Access Compliance Report

Public Rights-of-Way

(Pedestrian Signals)

Intersection ID: N/A	Main Street:	Cross Street: N/A	Location: N/A
ADA ID: 200EA51E58C2	Signal Type: One Push Button-Non APS	Overall Compliance: No	Severity Score: BTN 1: N/A BTN 2: N/A No BTN: N/A
Codes/Mitigation Info/Possible Solution		Field Measurements/Component Compliance

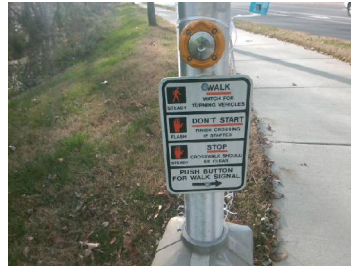
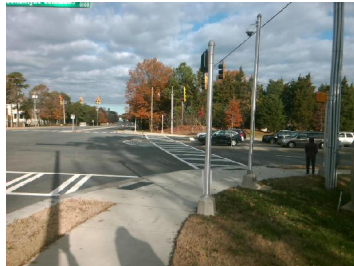
Yes	B 1 Clear Xing Direction?	ClearlyMarked	N/A	B 2 Clear Xing Direction?	N/A
	B 1 Crossing Direction	To SW		B 2 Crossing Direction	N/A
Yes	B 1 DistanceTo XWalk (in)	51.0	N/A	B 2 DistanceTo XWalk (in)	N/A
No	B 1 DistanceTo Curb (in)	134.0	N/A	B 2 DistanceTo Curb (in)	N/A
Yes	B 1 Diameter (in)	2.0	N/A	B 2 Diameter (in)	N/A

Possible Solutions: Replace Signal Push Button With APS Button on New Post. Remove & Relocate Sign.

PROW/ADA: TMUTCD 4e.08, R404.2, R404.3
